Access Compliance Report

Public Rights-of-Way

Intersection ID: 16319	Main Street: SLOAN_ST	Cross Street: TYSON_ST	Location: SE
ADA ID: F2377F51A881	Ramp Type: PerpDiag	Initial Pass/Fail: Fail	Overall Compliance: No
			Severity Score: 13.75

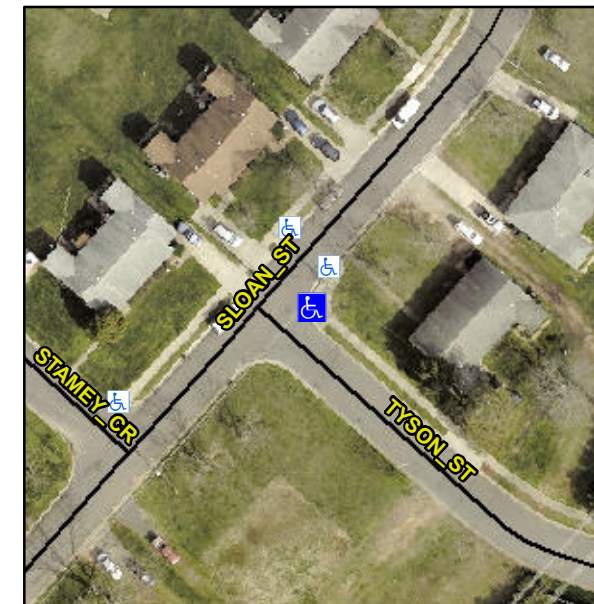
Not Found, R304.2.2, R304.5.3

Compliance	Description	Data	Compliance	Description	Data
N/A	Ramp Length (in)	25.0	No	Ramp Slope (%)	11.1
Yes	Ramp Width (in)	48.0	No	Ramp XSlope (%)	3.8
N/A	Flare Type LT	N/A	N/A	Flare Type RT	N/A
N/A	Flare Slope LT (%)	N/A	N/A	Flare Slope RT (%)	N/A
N/A	Flare Traversable LT?	N/A	N/A	Flare Traversable RT?	N/A
N/A	Landing Length (in)	N/A	N/A	DWS Provided?	N/A
N/A	Landing Width (in)	N/A	N/A	DWS Contrast?	N/A
N/A	Landing Slope (%)	N/A	N/A	DWS Length (in)	N/A
N/A	Landing X Slope (%)	N/A	N/A	DWS Full Width?	N/A
N/A	Landing Curb? (Y/N)	N/A	N/A	DWS Offset (in)	N/A
N/A	Shared Landing?	N/A			
N/A	Gutter Ponding?	N/A	N/A	Gutter Slope (%)	N/A
N/A	Gutter Lip Ht (in)	N/A	N/A	Gutter X Slope (%)	N/A
N/A	Painted X Walk1?	No	N/A	Painted X Walk2?	No
	X Walk 1 Direction	To NW		X Walk 2 Direction	To SW
N/A	X Walk 1 Width (in)	N/A	N/A	X Walk 2 Width (in)	N/A
	X Walk 1 Slope (%)	3.2		X Walk 2 Slope (%)	8.0
	X Walk 1 X Slope (%)	5.5		X Walk 2 X Slope (%)	0.8

Remove & Replace Curb Ramp With Two New Directional Ramps or Equivalent.
